WOOD MIDDLE SCHOOL MODERNIZATION AND NEW CONSTRUCTION—PHASE I INITIAL STUDY/MITIGATED NEGATIVE DECLARATION

RESPONSE TO COMMENTS DECEMBER 2023

**ALAMEDA UNIFIED SCHOOL DISTRICT
ALAMEDA, CALIFORNIA**

**Public Review Period: November 3, 2023, through December 3, 2023
SCH# 2023110126**

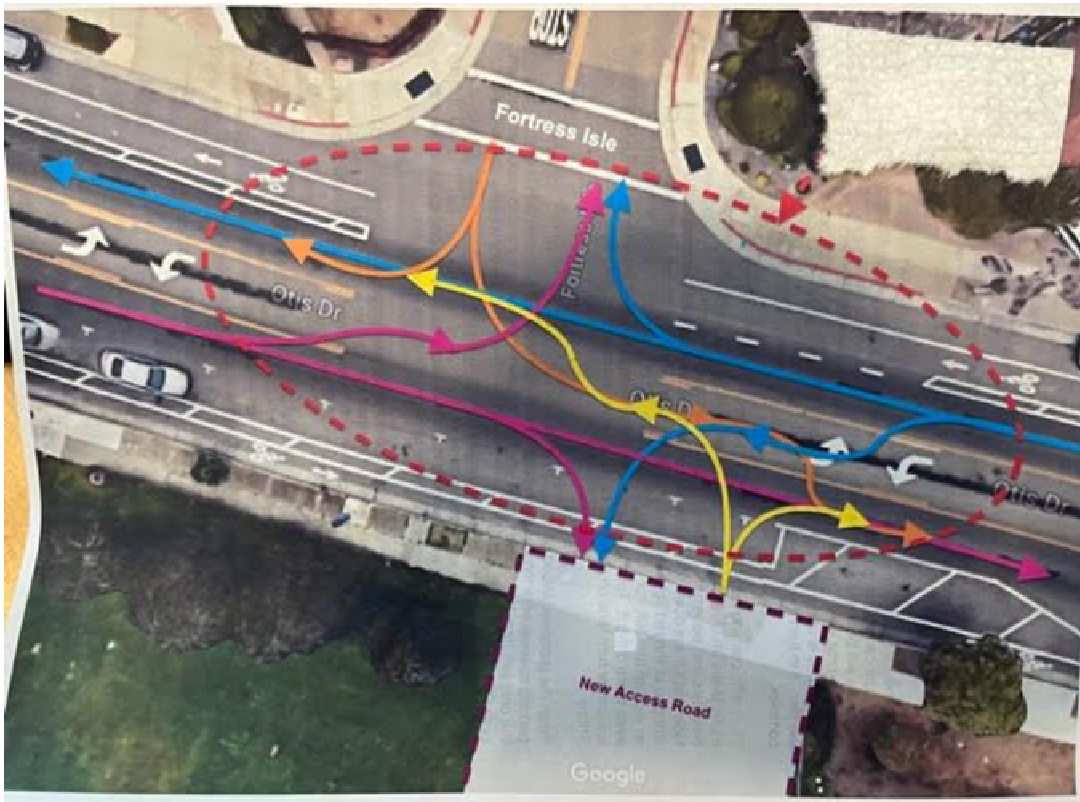
Do you plan to add a 4 way stop at this location?

Do you plan to add a signalized intersection at this location?

With No Signalization or additional stop signs I foresee a significant increase in traffic incidents here which would most likely involve one of the residents of Fortress Isle sooner or later.

Please see response above.

The District is sensitive to traffic safety of both its students arriving and leaving school as well as its neighbors. We will forward your comments to the traffic consultant for consideration.
